Edwin I. Hatch Nuclear Plant  
Response to Request for Additional Information:  
Technical Specifications Revision Request on  
Pressure-Temperature Limits

Page Change Instructions

Figure 3.4.9-1 (page 1 of 1)  
Pressure/Temperature Limits for  
Inservice Hydrostatic and Inservice Leakage Tests

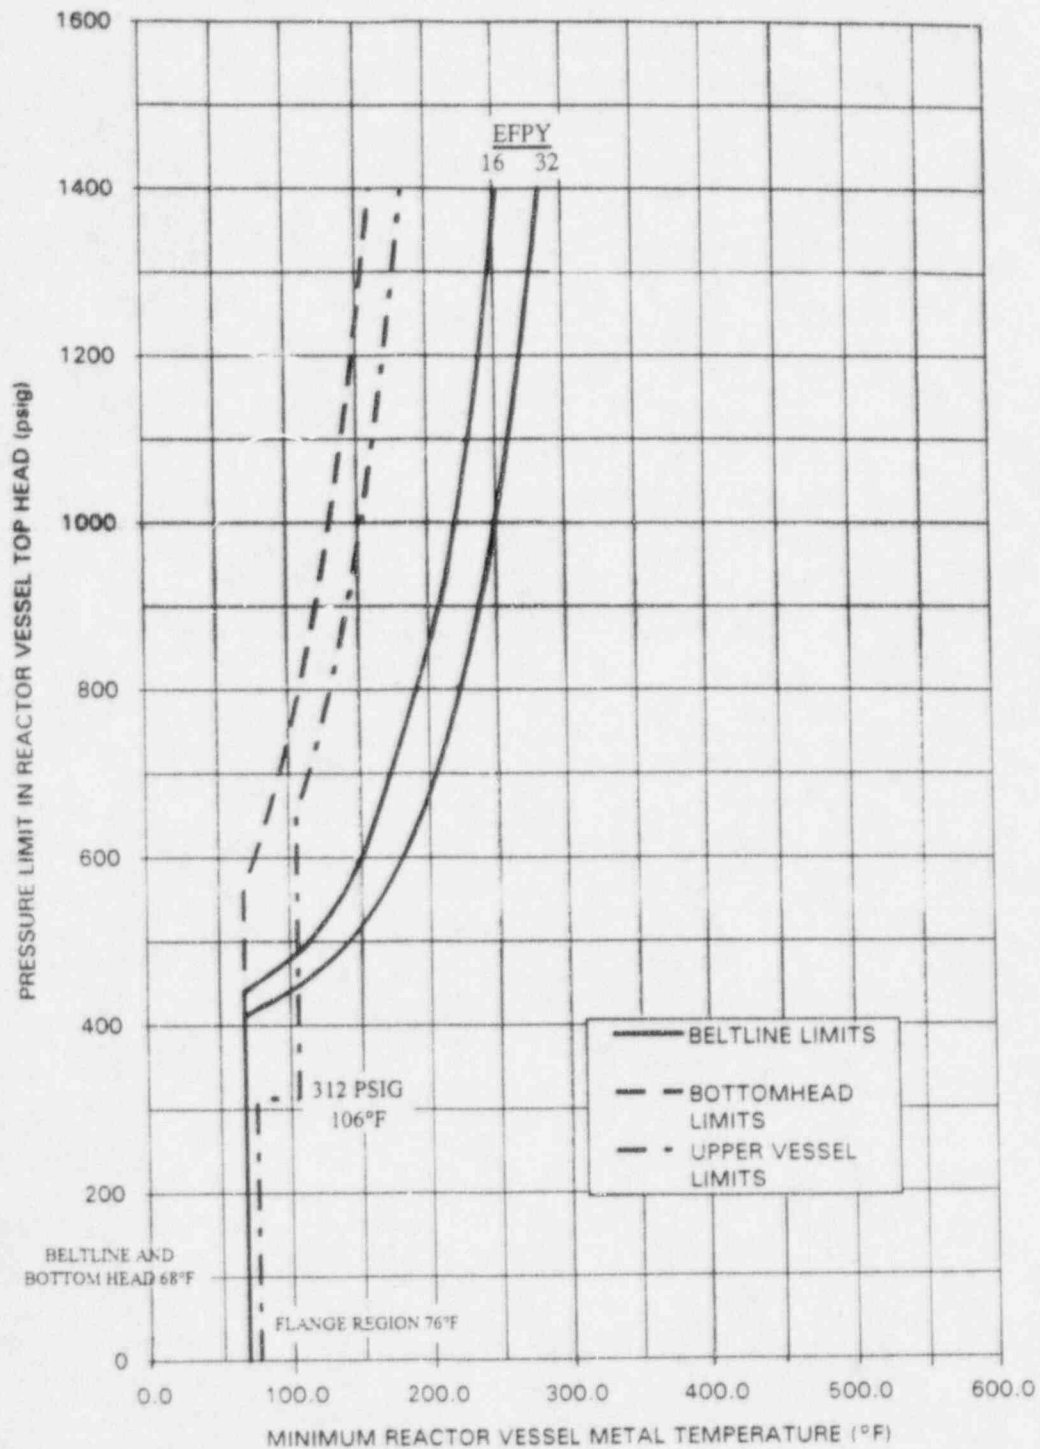
SURVEILLANCE	FREQUENCY
<p>SR 3.4.9.1 Verify:</p> <p>a. RCS pressure and RCS temperature are within the limits specified in Figures 3.4.9-1 and 3.4.9-2 during RCS inservice leak and hydrostatic testing, and during RCS non-nuclear heatup and cooldown operations; and</p> <p>b. RCS heatup and cooldown rates are <math>\leq 100^{\circ}\text{F}</math> in any 1 hour period during RCS heatup and cooldown operations, and RCS inservice leak and hydrostatic testing.</p>	<p>30 minutes</p>

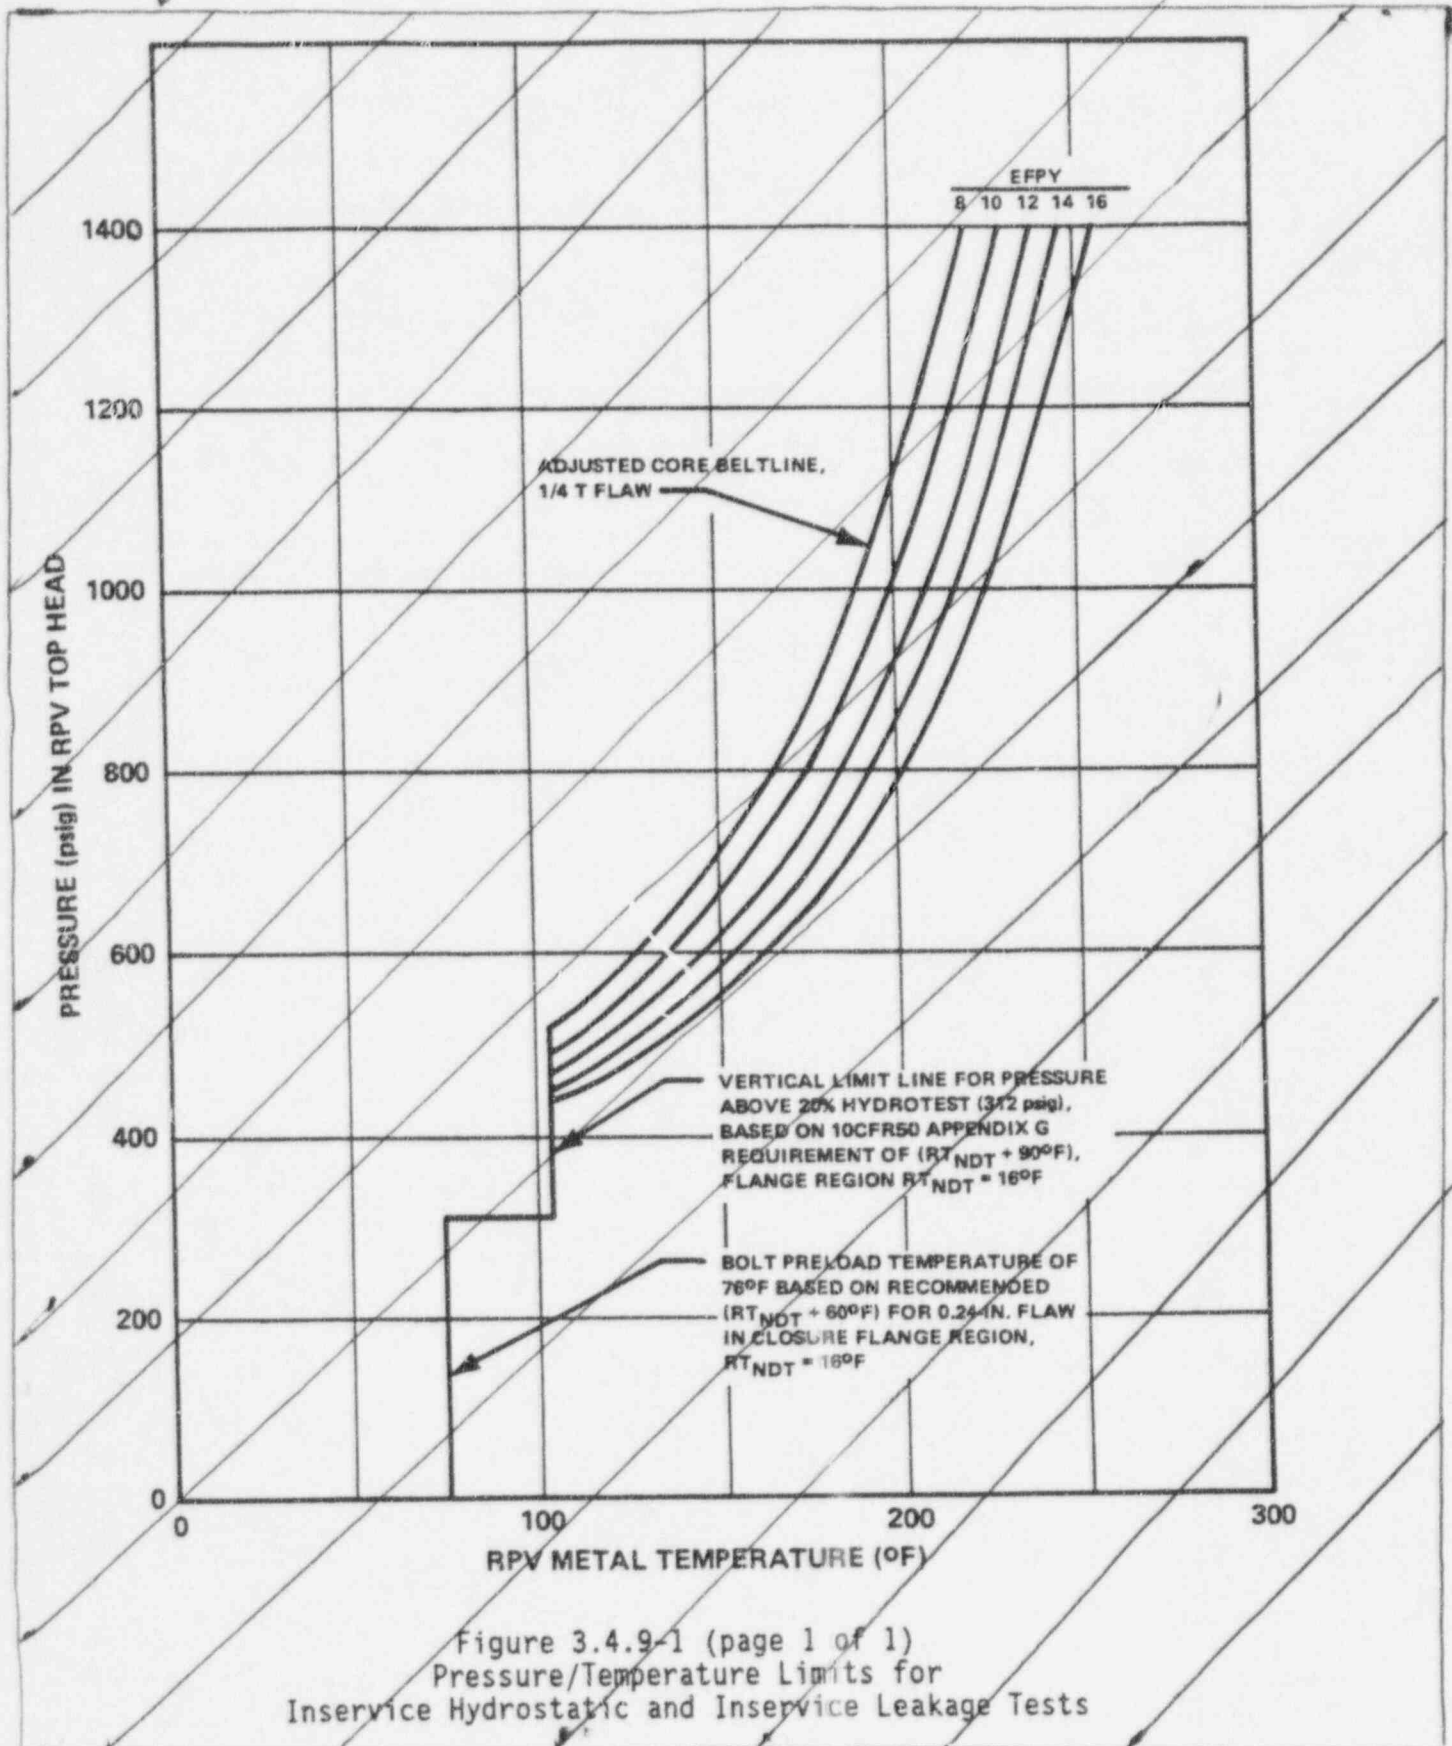
SURVEILLANCE		FREQUENCY
<p>SR 3.4.9.1</p> <p><i>replace with per synch on test page</i></p>	<p><i>delete</i></p> <p><del>NOTE</del></p> <p><del>Only required to be performed during RCS heatup and cooldown operations and RCS inservice leak and hydrostatic testing.</del></p> <p><del>Verify:</del></p> <p><del>a. RCS pressure and RCS temperature are within the limits specified in Figures 3.4.9-1 and 3.4.9-2; and</del></p> <p><del>b. RCS heatup and cooldown rates are <math>\leq 100^{\circ}\text{F}</math> in any 1 hour period.</del></p>	<p>30 minutes</p>

add when noted  
on page 34-22

- a. RCS pressure and RCS temperature are within the limits specified in Figures 3.4.9-1 and 3.4.9-2 during RCS inservice leak and hydrostatic testing, and during RCS non-nuclear heatup and cooldown operations; and
- b. RCS heatup and cooldown rates are  $\leq 100^{\circ}\text{F}$  in any one hour period during RCS heatup and cooldown operations, and RCS inservice leak and hydrostatic testing.

RCS P/T Limits  
3.4.9

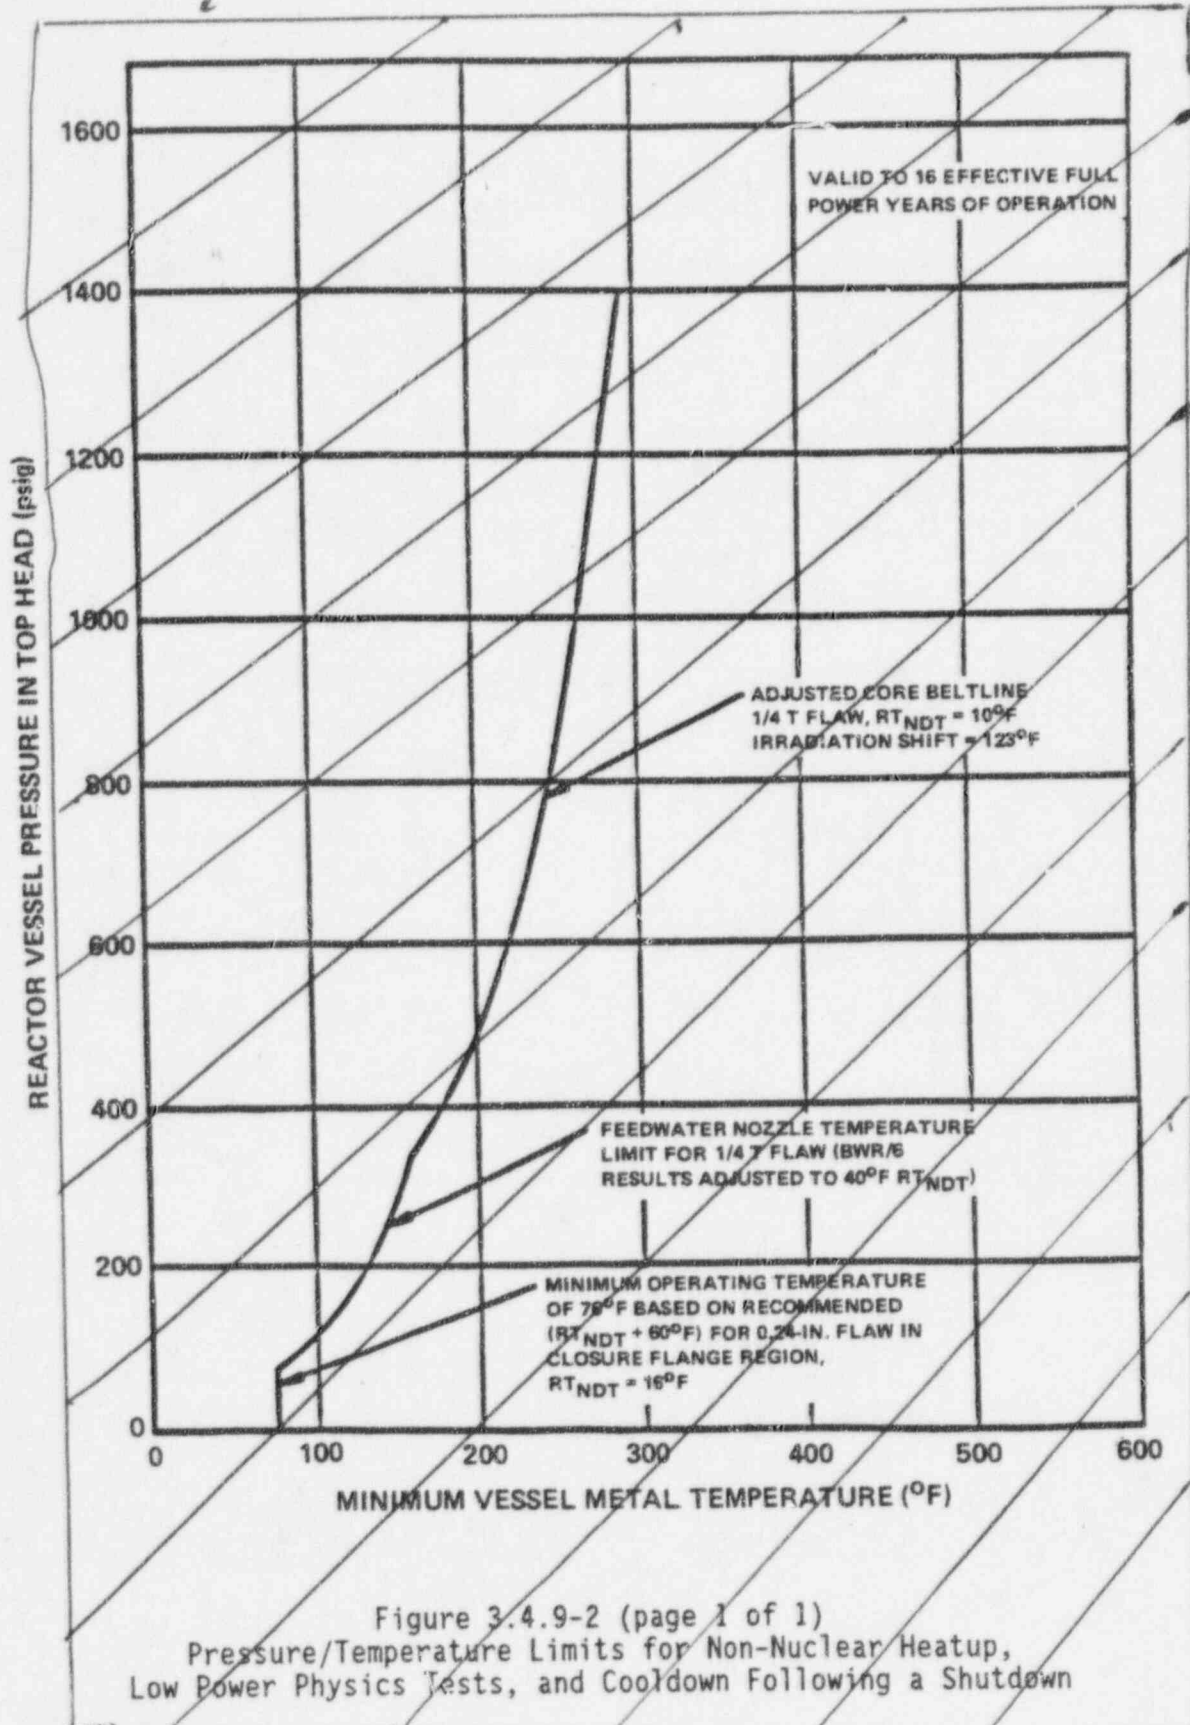
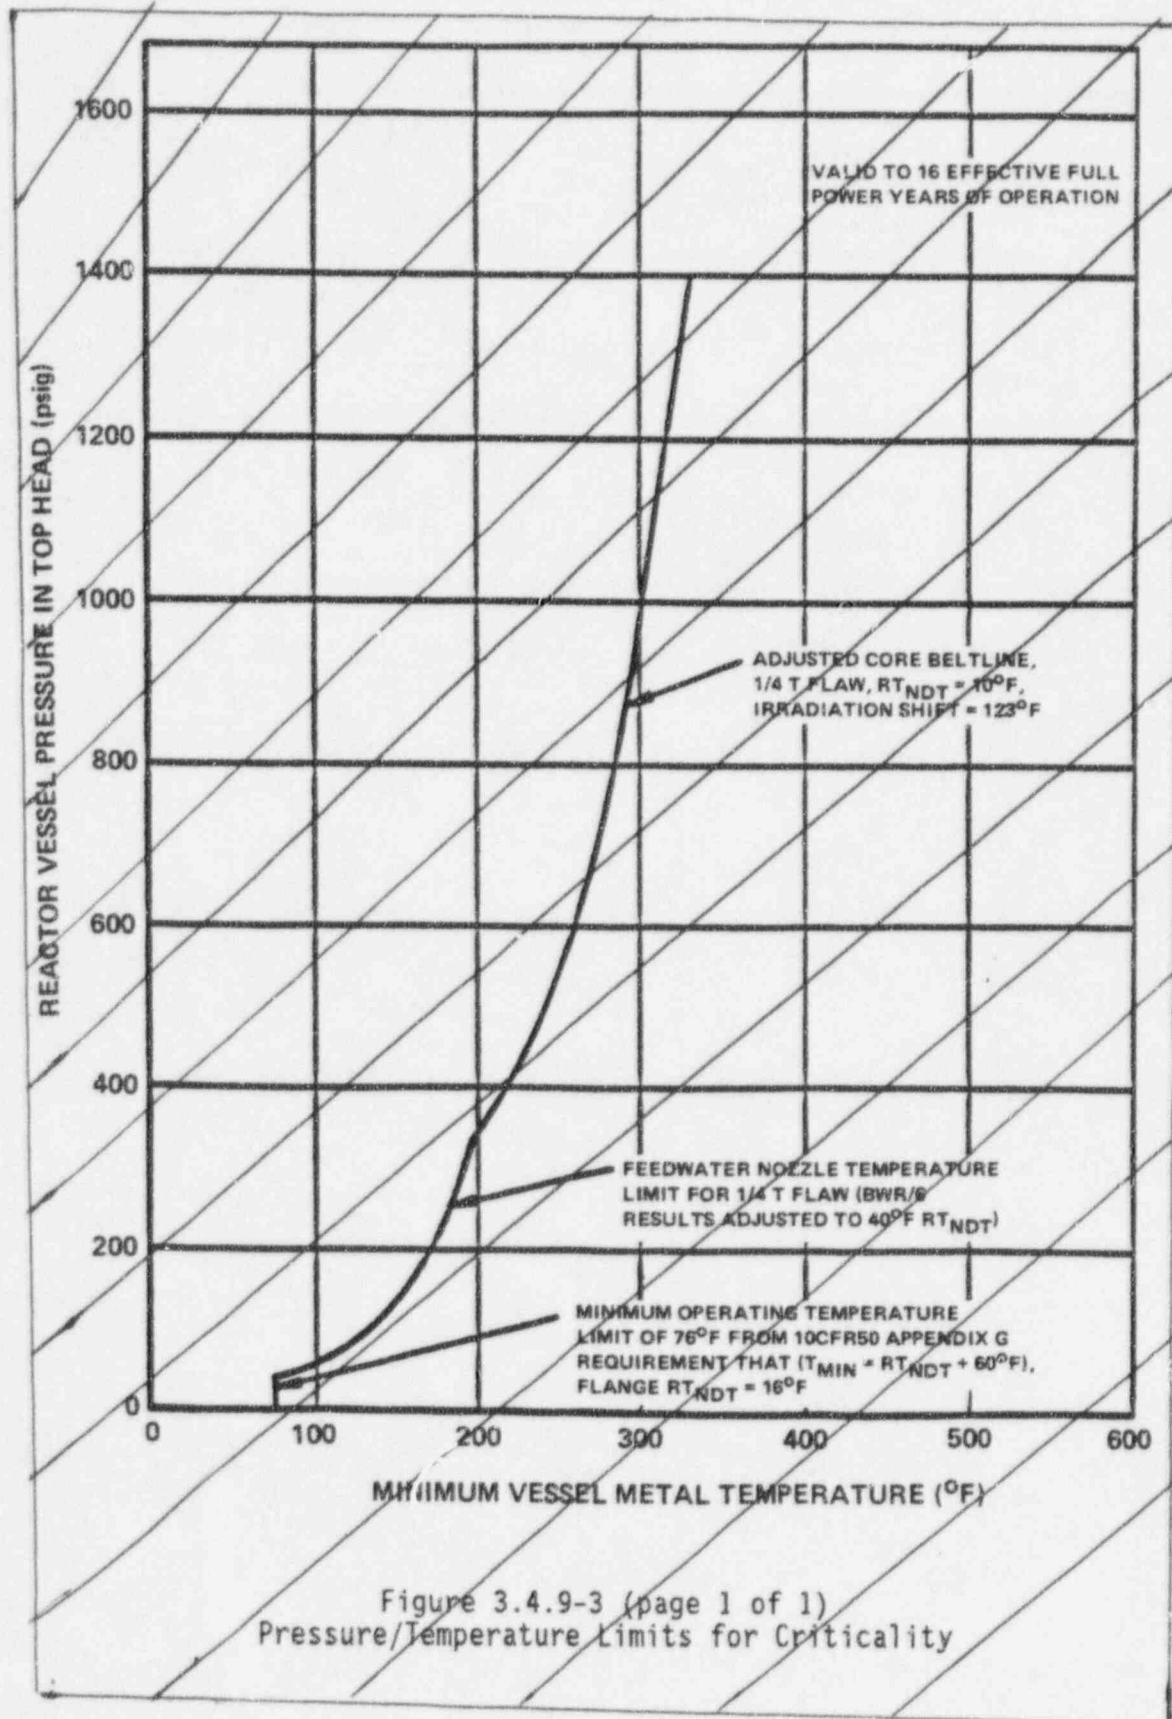
*Replace with  
Gizmo for next year*

Agree with Given  
from next page
